ACCESSION NBR: 8109140221 DOC. DATE: 81/09/09 NOTARIZED: NO DOCKET #
 FACIL: 50-220 Nine Mile Point Nuclear Station, Unit 1, Niagara Powe 05000220
 AUTH. NAME: AUTHOR AFFILIATION
 LEMPGES, T. E. Niagara Mohawk Power Corp.
 RECIP. NAME: RECIPIENT AFFILIATION
 IPPOLITO, T. A. Operating Reactors Branch 2

SUBJECT: Forwards response to NRC 810608 safety evaluation for
 environ qualification of safety-related electrical
 equipment.

NUCLEAR REGULATORY COMMISSION
SAFETY EVALUATION REPORT OF JUNE 8, 1981

NINE MILE POINT - UNIT 1

FIGURE 4-12A
LOSS OF COOLANT ACCIDENT
CONTAINMENT TEMPERATURE - WITH CORE SPRAY
STRETCH POWER

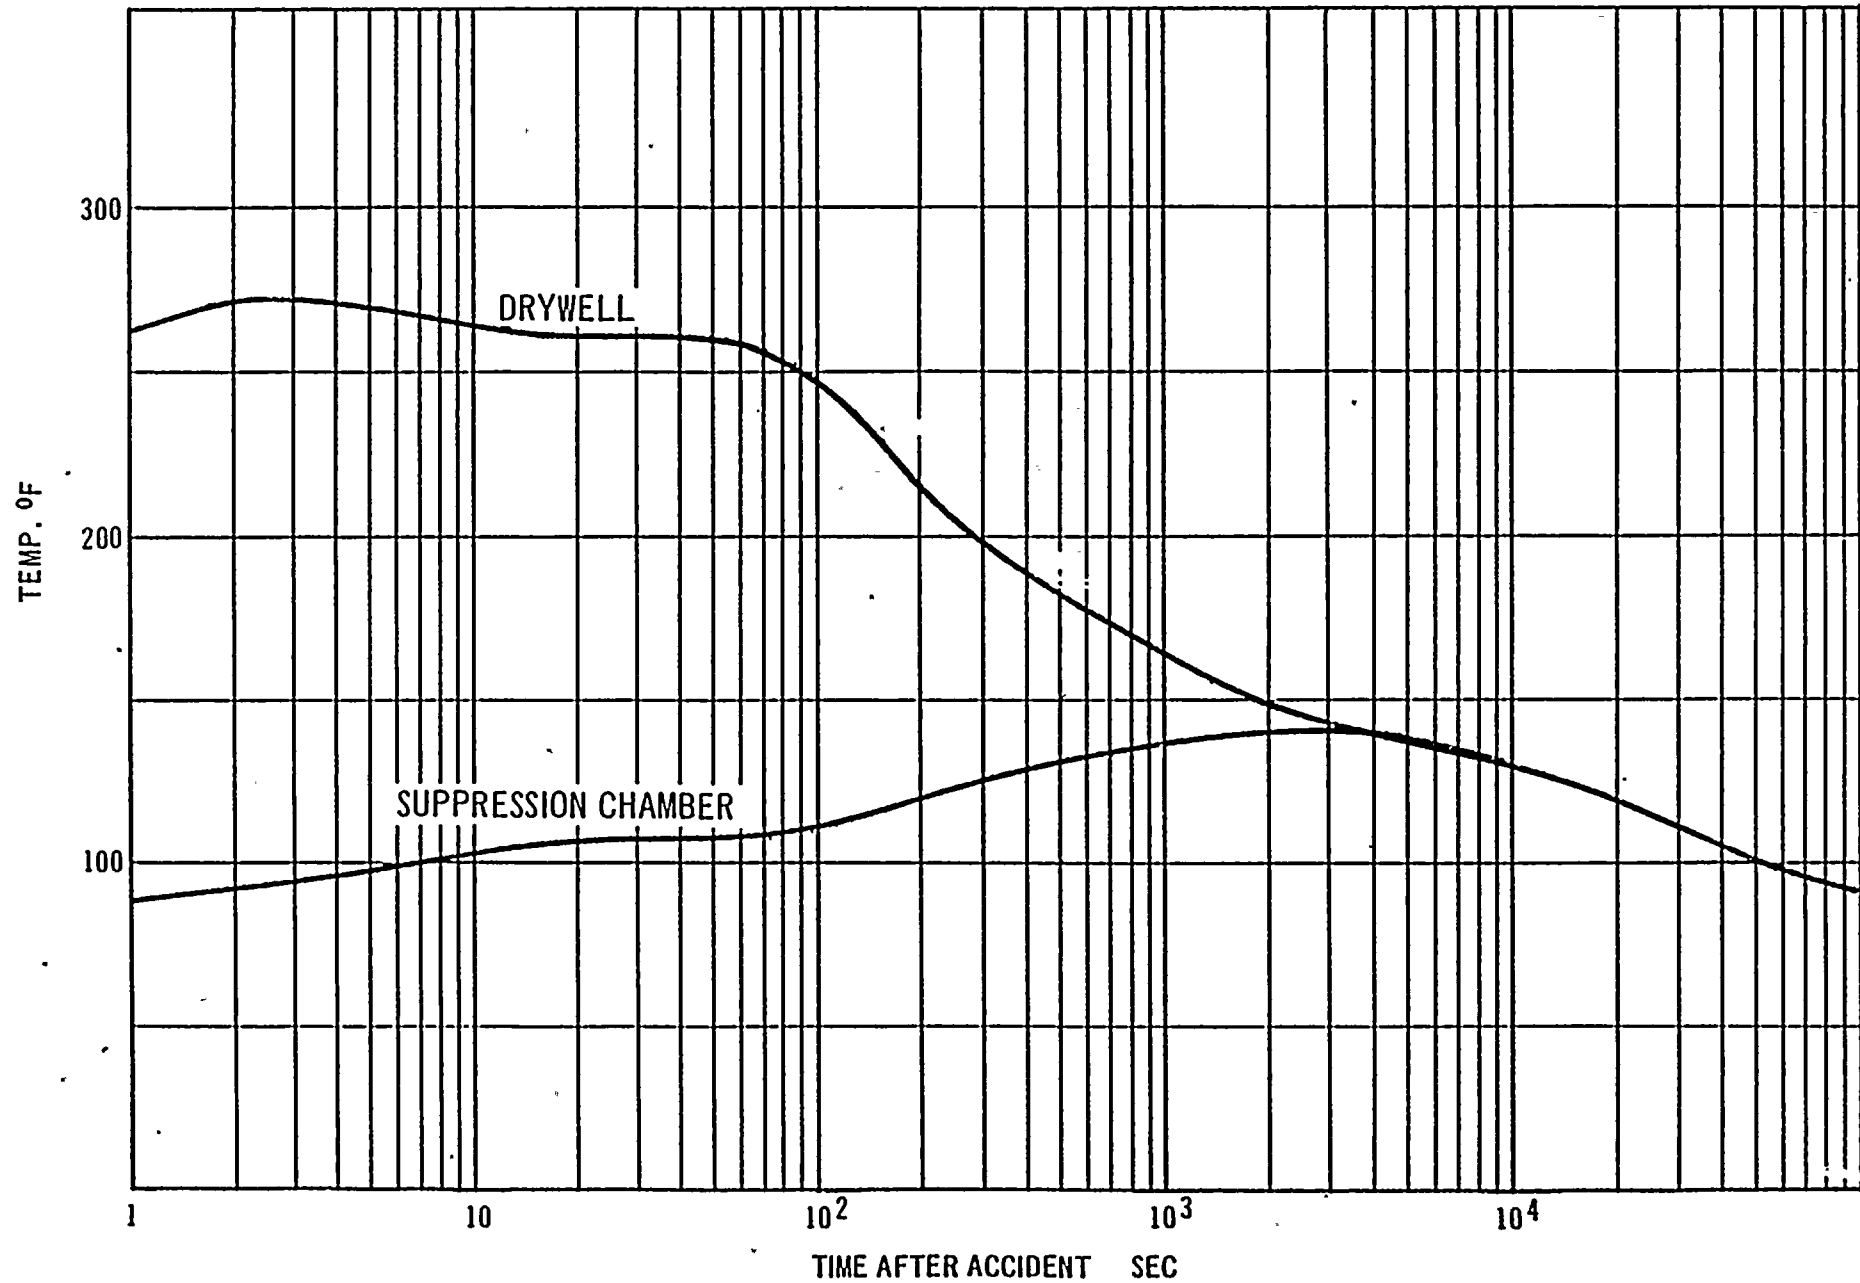
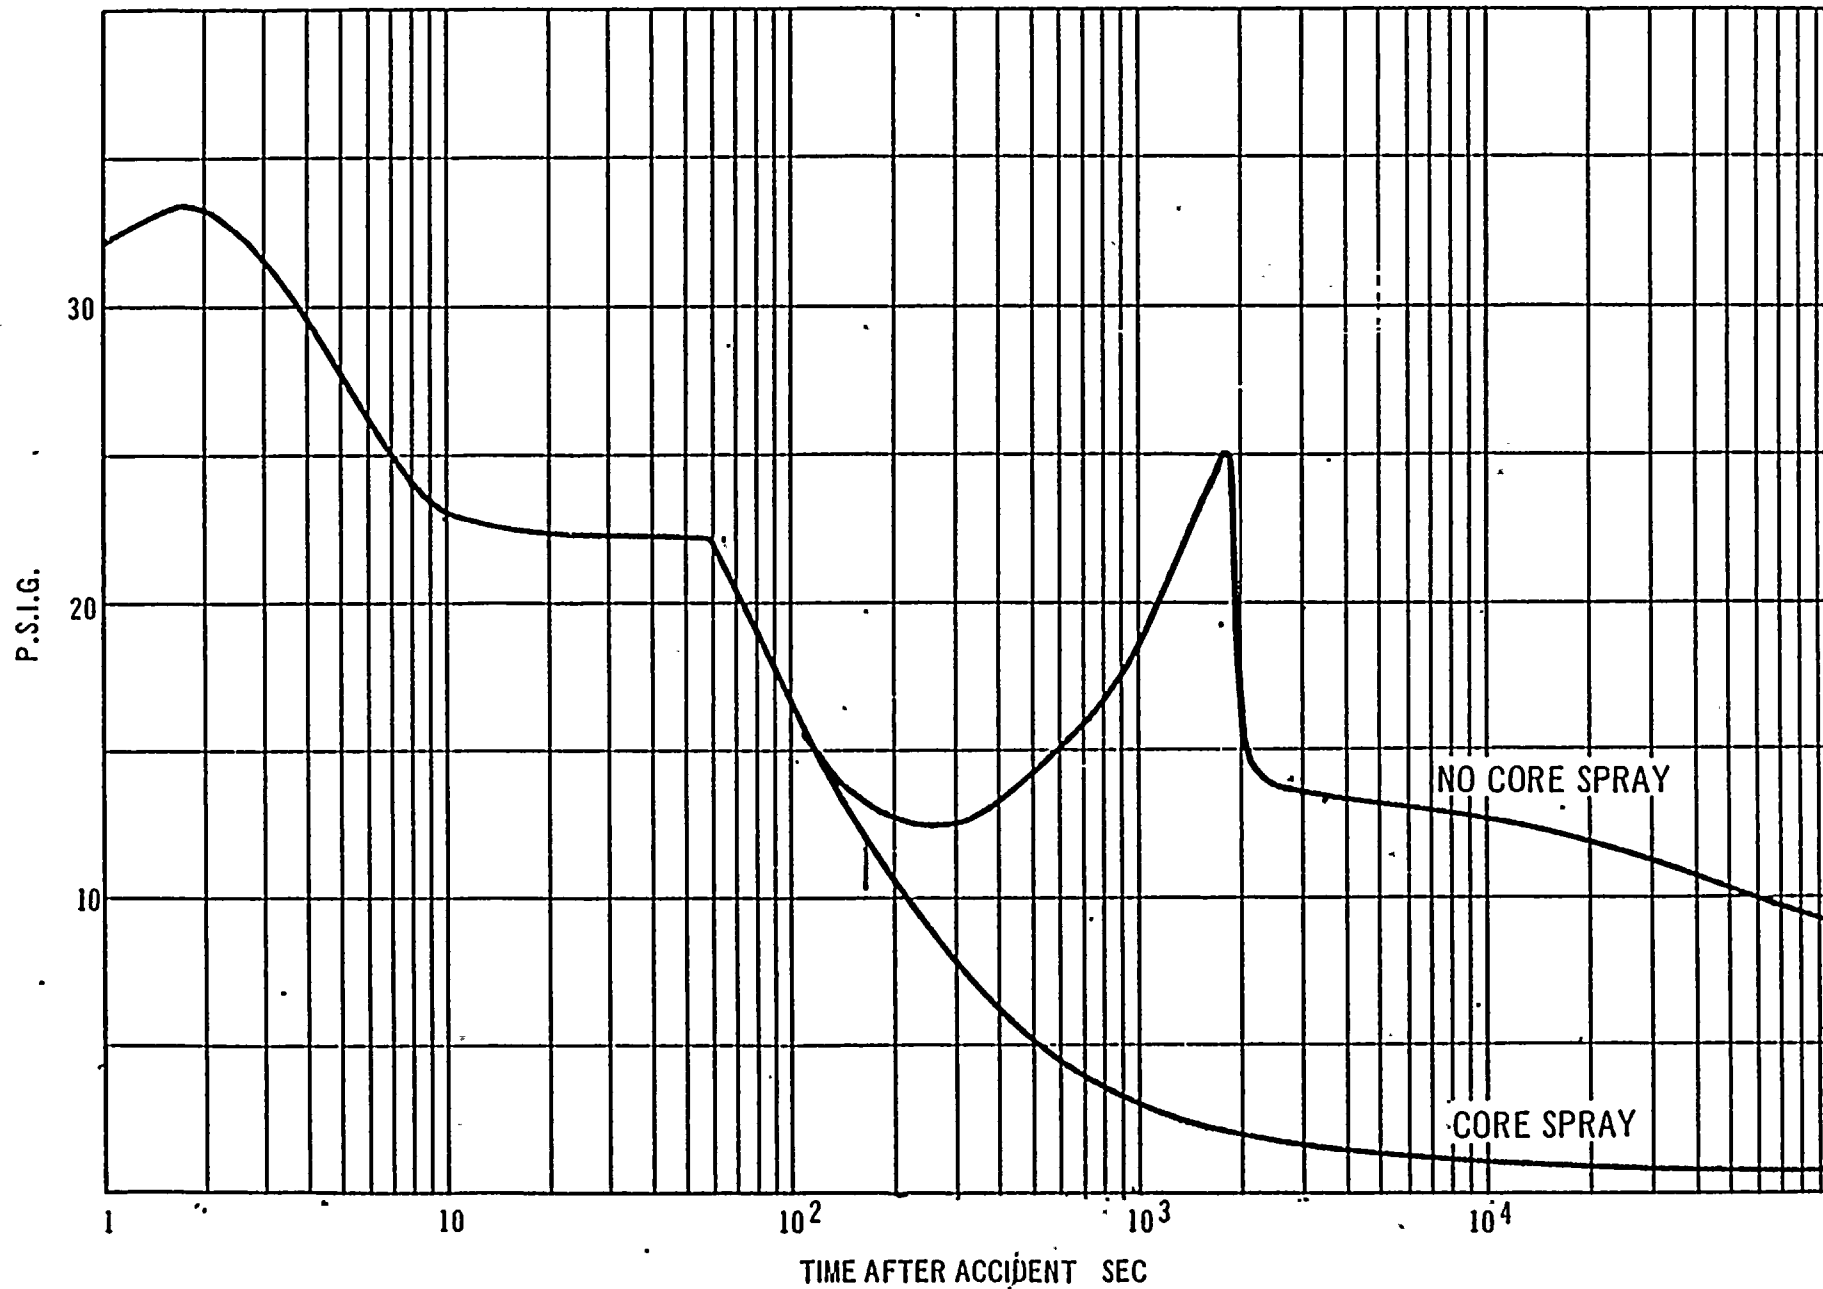
The limiting temperature/pressure versus time profiles submitted were different from the profiles in the FSAR. Consequently, the staff requested that the related analysis be provided.

In lieu of providing the analysis, NMPC has revised the limiting containment temperature/pressure profiles to those provided in the FSAR for recirculation line break, with 20°F added as margin to account for the possibility of local superheat. The FSAR curves were previously provided in the November 3, 1980 submittal, and are summarized in Table 4-1 and shown in Figures 4-12A and 4-12B of this report.

NMPC considers use of the FSAR curves plus 20°F appropriate for the following reasons:

- A) The FSAR states that the actuation of containment sprays would eliminate the possibility of superheat temperature in the bulk of the drywell.
- B) The NRC Guidelines, Section 4.2, allows that the LOCA environment envelopes main steamline break environments in plants with automatic containment spray systems not subject to disabling single failures.
